UNITED STATES PATENT AND TRADEMARK OFFICE

APPLICATION NO.	FILING DATE	FIRST NAMED INVENTOR	ATTORNEY DOCKET NO.	CONFIRMATION NO.
10/769,776	02/03/2004	Kenichi Shiba	Q79666	9279
23373	7590	08/23/2005	EXAMINER	
SUGHRUE MION, PLLC 2100 PENNSYLVANIA AVENUE, N.W. SUITE 800 WASHINGTON, DC 20037			CHEN, WEN YING PATTY	
			ART UNIT	PAPER NUMBER
			2871

Office Action Summary	Application No. 10/769,776	Applicant(s) SHIBA, KENICHI	
	Examiner Wen-Ying P. Chen	Art Unit 2871

FIG. 6

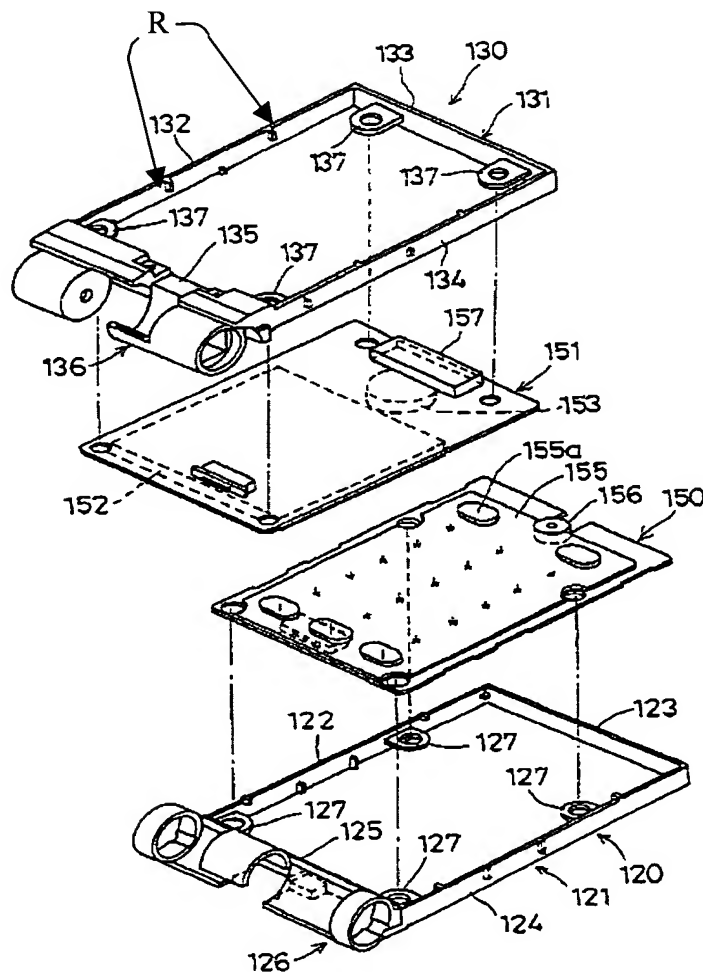
Takagi discloses all of the limitations set forth in claim 1 and further disclose in Figure 6 that the display comprises a frame portion (element 130) with mechanisms (element R, as shown in figure below) formed integrally with the frame portion that pushes the display against an inner face of the second casing body.

Takagi fails to disclose that the mechanisms (element R) which pushes the display have resiliency.

However, Kan-o discloses in Figure 1 a positioning portion (element 44), wherein is made to have resiliency for restricting movement of the display and to push the display against an inner face of the second casing (Column 9, lines 10-11). The resilient member is formed integrally with the frame portion (element 4, which comprises element 41 with projections element 44).

Therefore, it would have been obvious to one of ordinary skill in the art at the time the invention was made to construct a display device as taught by Takagi wherein the positioning portion has resiliency as taught by Kan-o, so that when the display is under external impact, the display is able to retain in the casing while still be fixed in the desired position.
